PERMIT

**ON-SITE SEWAGE DISPOSAL SYSTEM
 HOWARD COUNTY HEALTH DEPARTMENT
 BUREAU OF ENVIRONMENTAL HEALTH**

SUBDIVISION: Lime Kiln Valley II LOT NUMBER: 5

WALL CHECK DRAWING
LOT 5
LIME KILN VALLEY
PHASE 1 AND 2
PLATS 19732-19738

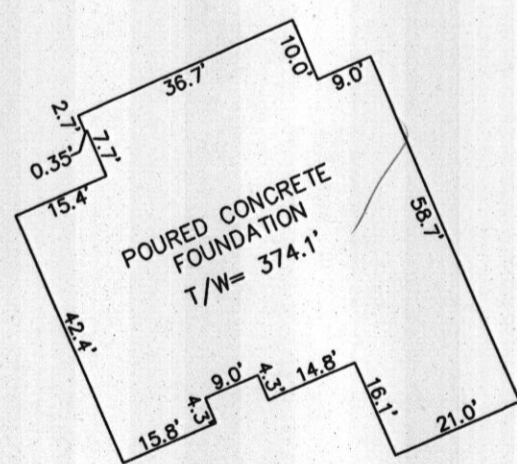
11/14/08 Keep tanks out of swales.
 set D box top middle of SDB.
 Pump 30x48' trench

back towards House. 6' ETC. is acceptable. (KW) 11/17/08
 Both tanks set. 4" SMC made. Must maintain no more than 42" of cover on tanks (KW) 11/19/08 Top trench completed. noticed stone in inlet w/ cleaner stone. Need to get clean stone w/ no clay. (KW) 11/20/08 contractor finished trenches. 2" FOMs just about finished. Pump installed, avoids 1/2 HP. Will need a P/A test for final approval. OK to backfill (KW) 12/5/08 P/A test. OK.
